Re: Supporting information for the PER and IESC responses for the Vulcan South Project

Date	16 August 2024
Attention	Damien Plucknett
Company	METServe
WRM ref.	1571-34-B2
Subject	Vulcan South – Supporting information for the PER responses

Supporting information and responses to the Independent Expert Scientific Committee Information Request relating to surface water

Figure 4.1 Forecast MWD8 inventory

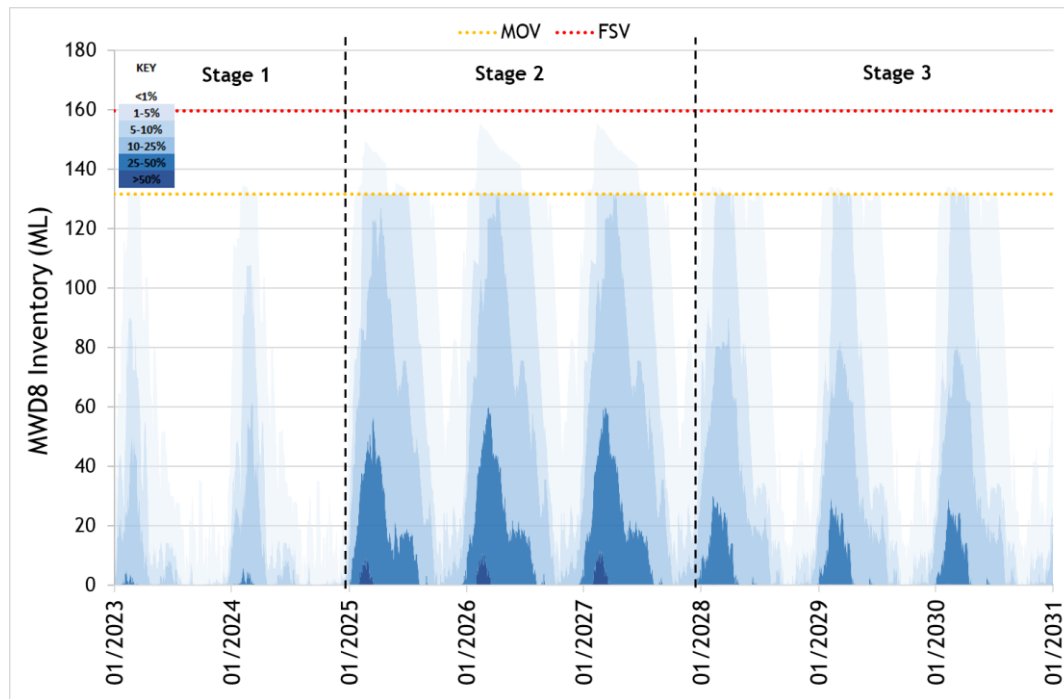
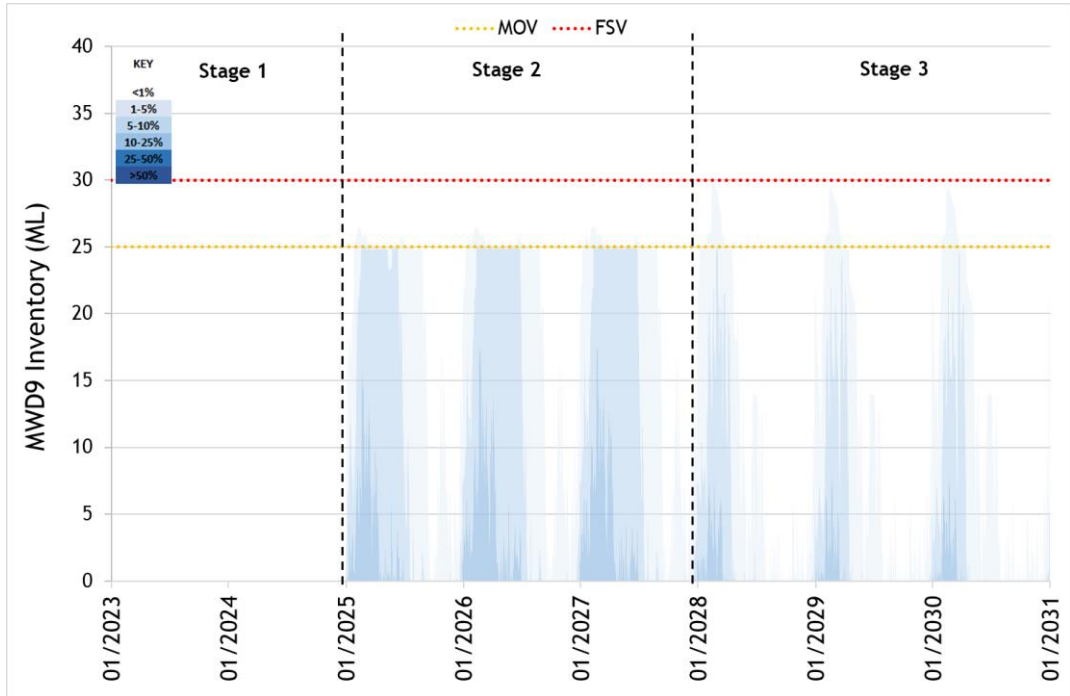
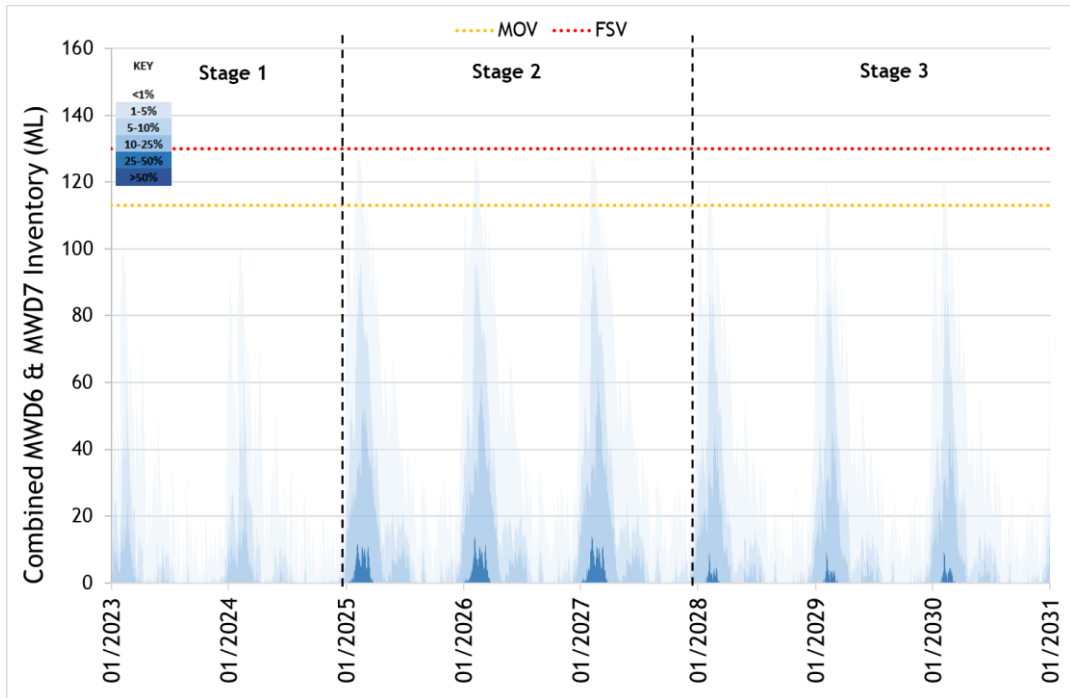
12	<p>The proponent has optimised the water management system to reduce the risk of uncontrolled releases during operations and it is stated (e.g. WRM 2023, p. 111) that no spills of MAW to the external environment will occur under any modelled climate sequence. While some sensitivity analyses were undertaken with respect to changing climate and haul-road dust suppression demands, little consideration appears to have been given to the uncertainties inherent in the dewatering rates associated with rainfall intensities and variable storm durations. Some assessment should be made of system performance under more extended and extreme storms, noting that this should now include allowance for the 1.3 °C of global warming that has occurred over the historical period used to derive design rainfall information (DCCEE, 2023).</p>	Section 4
13	<p>As part of the water management system, the proponent will construct sediment dams where sediment will be allowed to settle (WRM 2023, p. 75) before water can overflow to Hughes and East creeks. There is limited discussion on the frequency of sediment removal from the sediment dams and whether this sediment might be contaminated (and therefore require suitable treatment or containment). The proponent should provide more information about sediment dam maintenance and the disposal of any sediment removed from the dams. There should also be a detailed monitoring program of sediment quality in the dams to ensure that any material released or removed does not pose a contamination risk.</p>	Refer to ESCP (WRM, 2024b)

Figure 4.1 shows the forecast inventory for MWD8 which is the key out-of-pit mine affected water storage, controlling the dewatering of the pit. The results show the 1%ile (wettest climatic conditions), 5%ile, 10%ile, 25%ile and 50%ile traces. The model results show the following:

- The MWD8 inventory is maintained below the FSV for all climatic conditions assessed and therefore is not predicted to spill under any modelled climate sequence.
- The MWD8 inventory is maintained below its MOV for 5%ile and drier conditions in Stage 1 and 25%ile & drier conditions in Stages 2 & 3. This means pit and mine dam dewatering is restricted under 1%ile in Stage 1 and 10%ile and wetter conditions in Stages 2 and 3.
- Under the 50%ile trace, the MWD8 inventory is maintained below 12 ML for the entire mine life.
- Under very wet (1%ile) conditions, MWD8 has an inventory of up to 156 ML during Stage 2.
- Under wet (10%ile conditions), MWD8 has a maximum inventory of approximately:
 - up to 62 ML during Stage 1; and
 - up to 132 ML during Stage 2 and 3.

Figure 4.1 shows the forecast inventory for MWD9. The results show the 1%ile (wettest climatic conditions), 5%ile, 10%ile, 25%ile and 50%ile traces. The model results show the following:

- Under the 1%ile (wettest climatic conditions), the MWD9 inventory reaches the FSV under the reduced dewatering scenario. However, in the event that the proposed dewatering is constrained, there is sufficient storage within the MAW system for MWD9 to dewater to prevent uncontrolled releases.
- Under wet (10%ile conditions), MWD9 has a maximum inventory of approximately up to 18 ML during both Stage 1 & 2.

Figure 4.3 shows the annual maximum forecast combined inventory for MWD6 and MWD7. The results show the 1%ile (wettest climatic conditions), 5%ile, 10%ile, 25%ile and 50%ile traces. The model results show the following:

- Under the 1%ile (wettest climatic conditions), the MWD6 and MWD7 inventory reaches the FSV under the reduced dewatering scenario and indicate that the mine dams spill into MWD8 very infrequently (i.e. less than 1% of the time).
- Under the 50%ile trace, the mine water inventory is maintained well below the MOV for all years.
- The maximum water inventory only rises above the MOV under conditions wetter than the 5%ile during all stages.

Figure 5.1 Forecast annual sediment dam releases to Hughes Creek

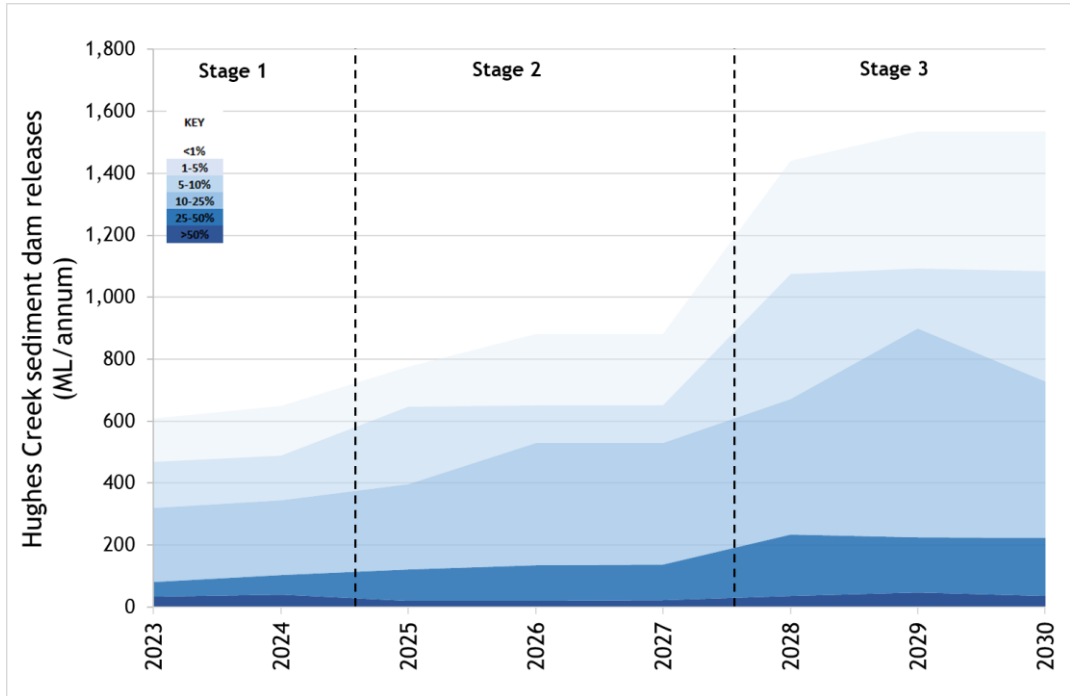
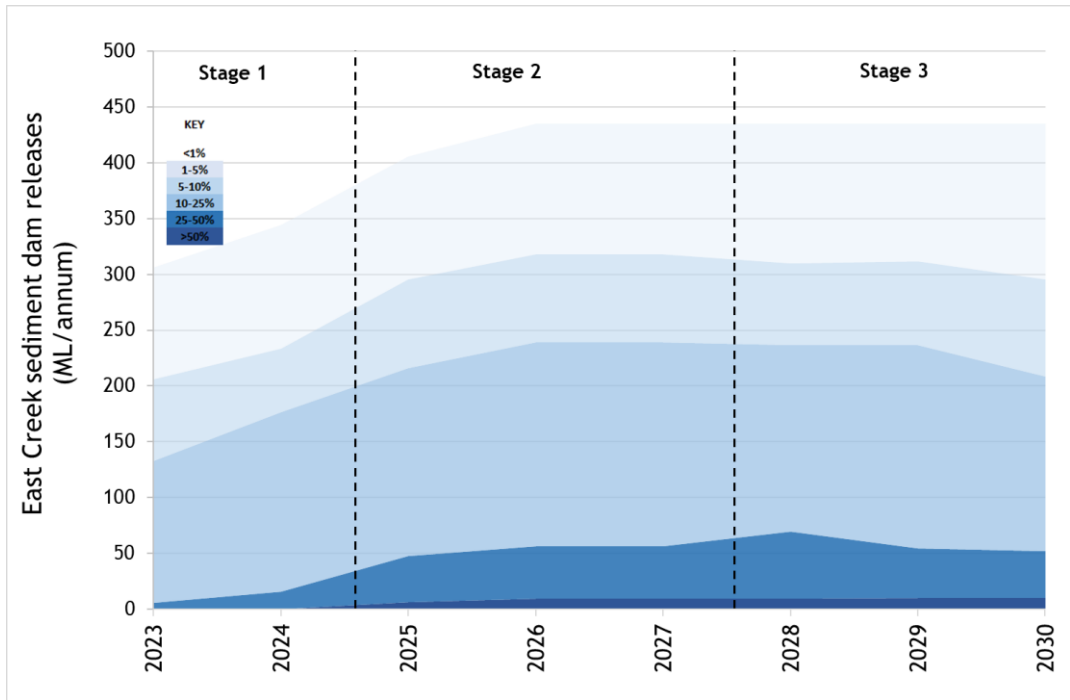
14	<p>It is also noted that no sensitivity analysis was undertaken on the inflow estimates computed for mine water balance dynamics using the Australian Water Balance Model (AWBM) rainfall-runoff model. The parameters adopted for this model are solely based on regional information without site-specific calibration, and as such the likelihood of overflows from the 20 sediment dams is subject to high uncertainty. This uncertainty has not been considered in the performance assessment of forecast inventory and should be accounted for in further sensitivity analyses.</p>	Section 5
15	<p>The proponent discusses cumulative impacts on water quality from the project and surrounding mines (e.g. Saraji Mine Complex, Peak Downs, Caval Ridge) but does not provide details on potential cumulative impacts to surface water flows or cumulative impacts from the proposed project and other pits in the mining area (e.g. Matilda and Jupiter pits).</p> <p>a. The proponent has provided limited discussion about potential changes to surface water flows as a cumulative effect from different projects. Many of the surrounding streams have been diverted by other mines and these mines also collect rainfall runoff within water management systems. The proponent should assess the potential changes to surface water flows arising from the combined effects of stream diversions, changes in flooding and decreased stream flows due to rainfall runoff captured by the water management systems.</p> <p>b. The proponent should assess potential cumulative impacts to surface water for the entirety of the approved and planned operations at the Vulcan Complex to ensure an understanding of overall potential impacts to surface water.</p>	Section 3

Figure 5.1 shows the forecast annual sediment dam releases to Hughes Creek. Figure 5.2 shows the forecast annual sediment dam releases to East Creek. The model results indicate that:

- The predicted sediment dam releases to Hughes Creek progressively increases over the mine life. This is due to sediment dams which release to Hughes Creek progressively being constructed

- The predicted sediment dam releases to East Creek increase in Stage 2 compared to Stage 1 before decreasing again in Stage 3. This is due to no new sediment dams draining to this creek being constructed at the commencement of Stage 3. The surface water catchment areas do not change between Stages 2 and 3, however mine demands for the sediment dam water increase in Stage 3.

- Under wet (10%ile) conditions, the annual volume of sediment dam releases to Hughes Creek is approximately:
 - up to 344 ML/yr during Stage 1;
 - up to 529 ML/yr during Stage 2; and

- up to 899 ML/yr during Stage 3.
- Under wet (10%ile) conditions, the annual volume of sediment dam releases to East Creek is approximately:
 - up to 177 ML/yr during Stage 1;
